FINAL PLAT OF
"ASHBROOK MEADOWS AT CHISHOLM CREEK"

RE: S/D 98-107 -- One-Step Final Plat of ASHBROOK MEADOWS AT CHISHOLM
CREEK ADDITION

RE: S/D 98-107 -- One-Step Final Plat of ASHBROOK MEADOWS AT CHISHOLM
CREEK ADDITION

CASE NUMBER: S/D 98-107 - ASHBROOK MEADOWS AT CHISHOLM CREEK

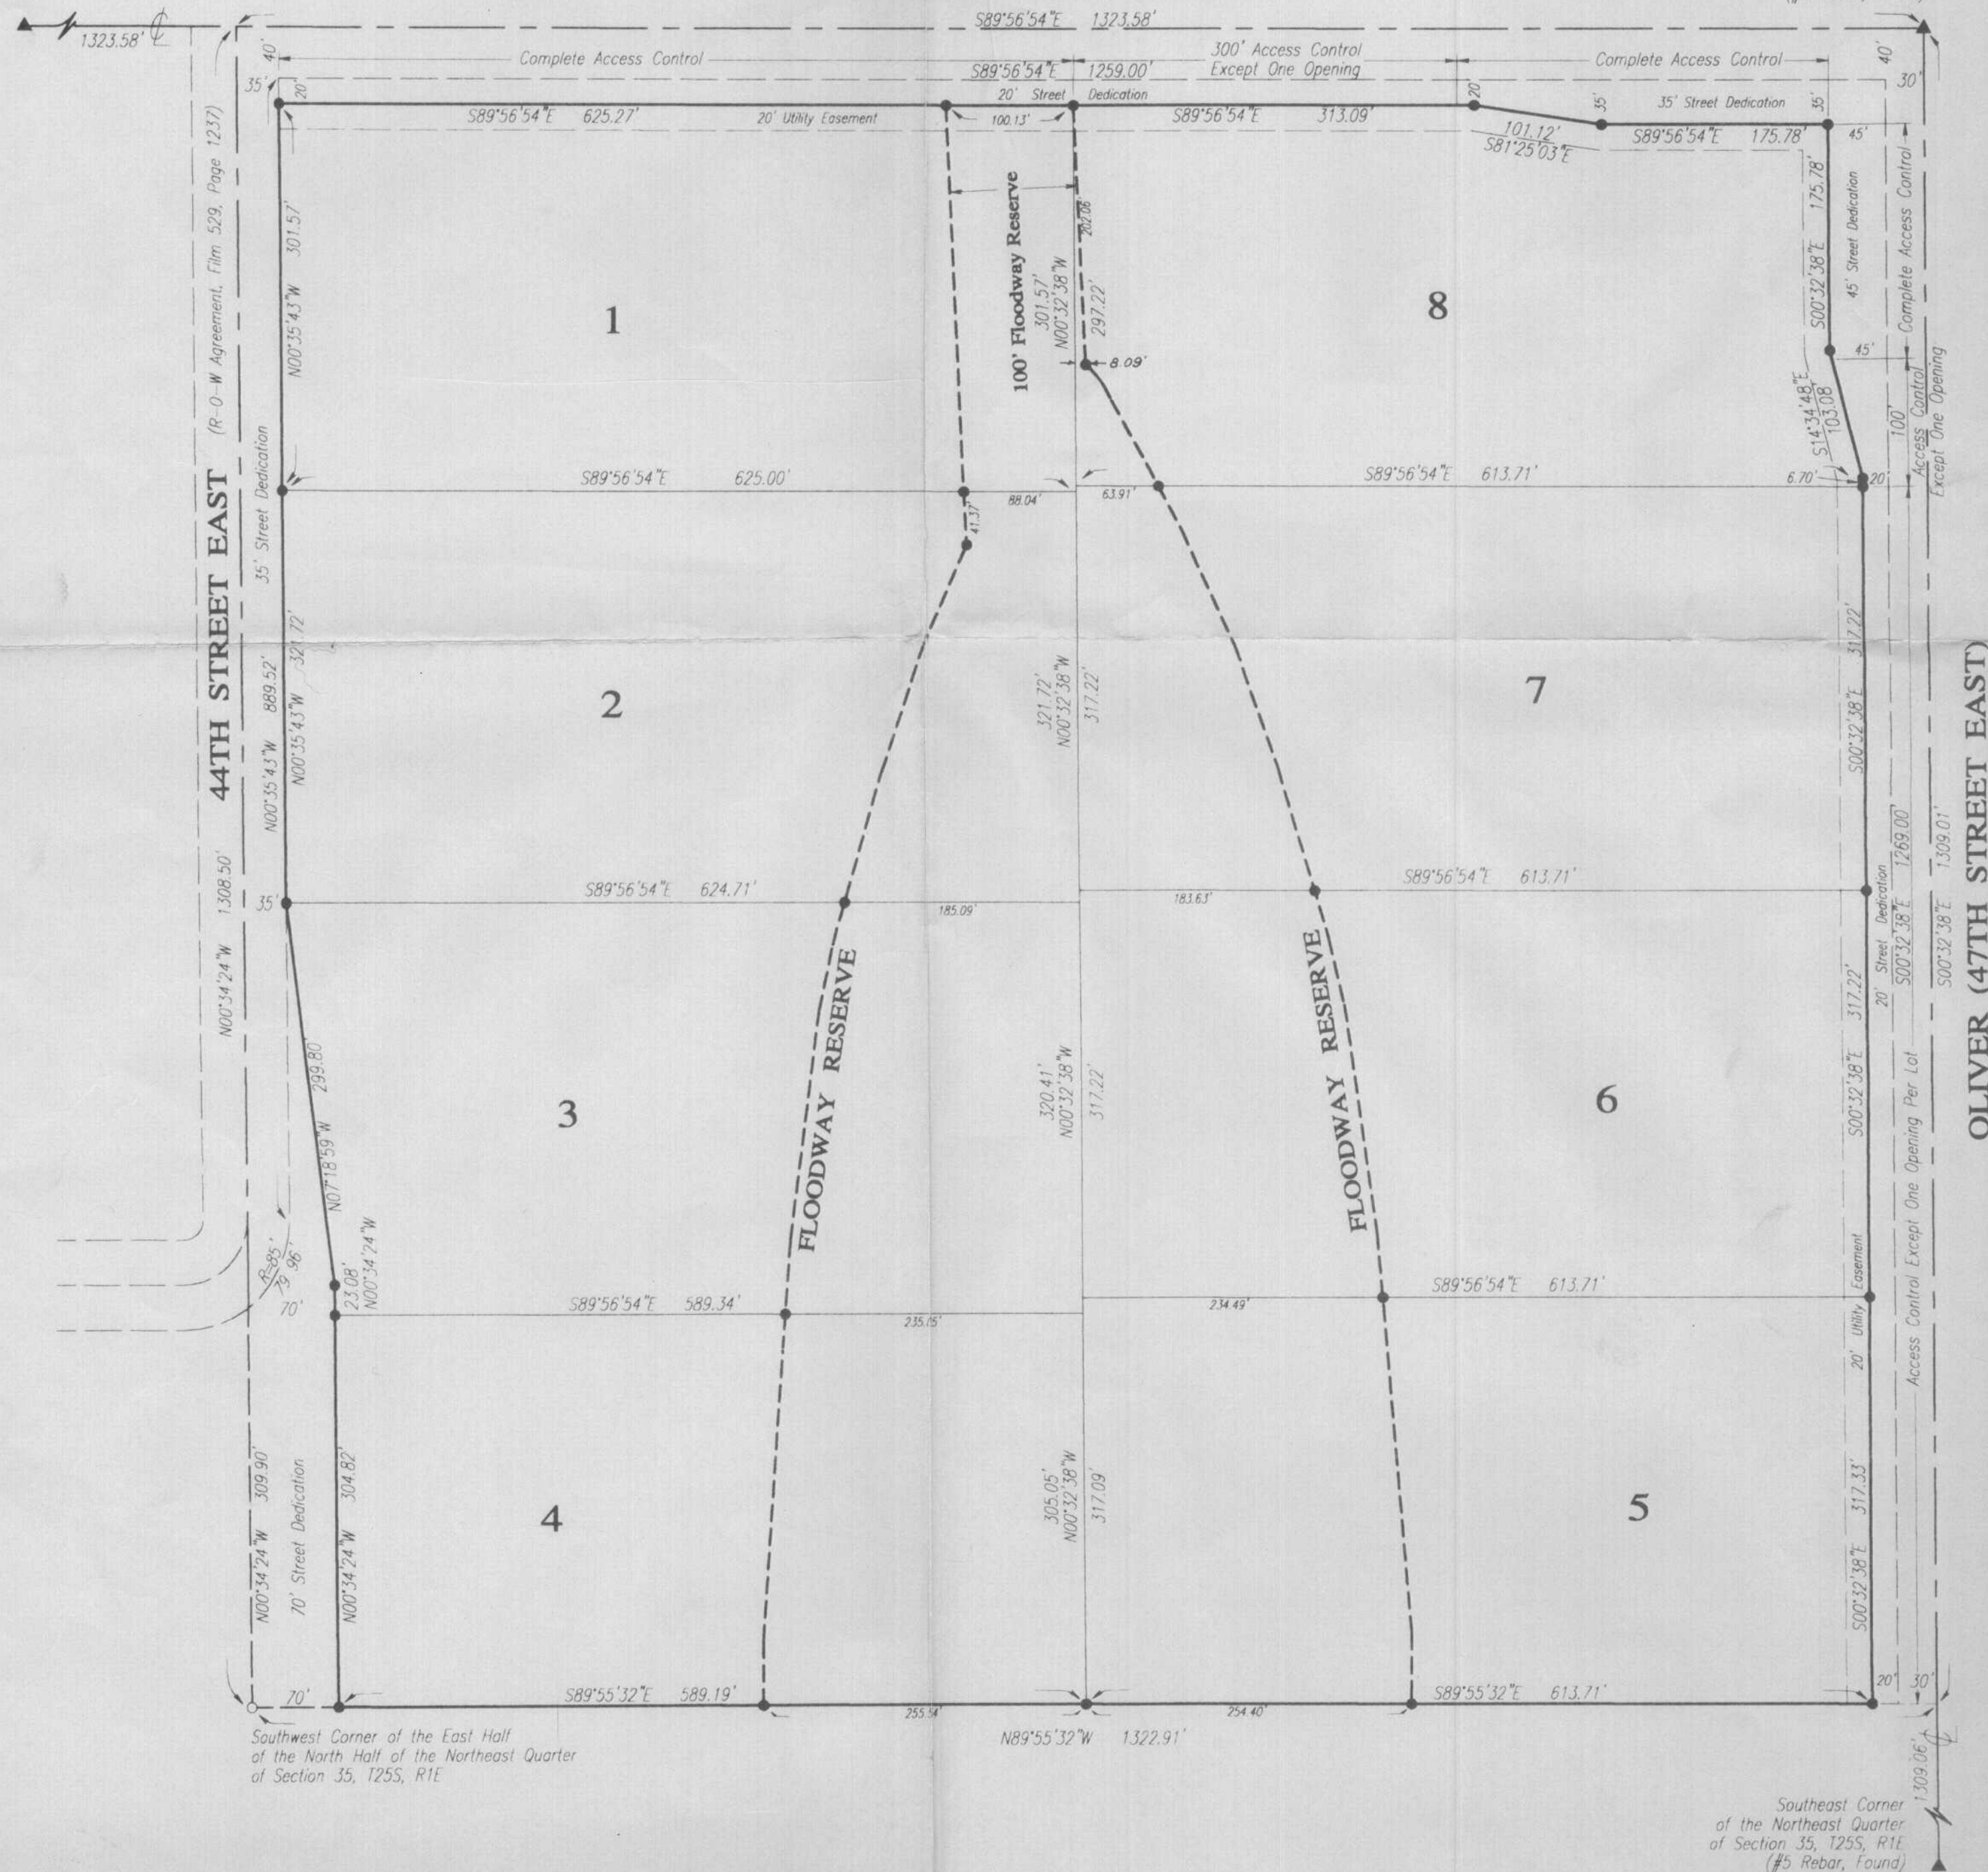
- A. Since neither municipal water nor sanitary sewer is available to serve this property, the applicant shall contact the Environmental Health Division of the Health Department to find out what tests may be necessary and what standards are to be met for approval of on-site sewerage facilities and water wells. A memorandum shall be obtained specifying approval. The lots will consist of less than 4.5 acres, in violation of the Subdivision regulations after dedication of right-of-way for adjoining streets. *The Subdivision Committee has approved a modification to the 4.5 acre minimum lot size.*

- C. County Engineering needs to comment on the status of the applicant's drainage plan. *The drainage plan is approved.*
- D. County Engineering needs to comment on the access controls. The plat denotes one access opening along 85th St. North for the lot adjoining Oliver, and one access opening per lot along Oliver.

- E. The Subdivision regulation require a 50-ft half street right-of-way for section line roads. The plat denotes a contingent right-of-way dedication for Oliver (currently 30-ft half-street right-of-way) and 85th St. North (currently 40-ft half street right-of-way). County Engineering needs to comment on the need for an outright dedication. *An outright dedication of right-of-way is required for Oliver and 85th St. North.*

- ✓ F. Based upon the platting binder, the site is in the ownership of another party which must be made a signatory to the plat or a document provided that such interest is no longer involved in this site.

- ✓ G. The City Council signature block needs to be added as this plat is located within three miles of the City.
- ✓ G. The applicant shall install or guarantee the installation of all utilities and facilities which are applicable and described in Article 8 of the MAPC Subdivision Regulations. (Water service and fire hydrants required by Article 8 for fire protection shall be as per the direction and approval of the Chief of the Fire Department.)

- H. The applicant's engineer is advised that the Register of Deeds is requiring the name(s) of the notary public, who acknowledges the signatures on this plat, to be printed beneath the notary's signature.

- L. Perimeter closure computations shall be submitted with the final plat tracing.

N. The representatives from the utility companies should be prepared to comment on the need for any additional utility easements to be platted on this property. *Southwestern Bell has requested additional easements.*

P. An access easement will need to be established for Lot 4.
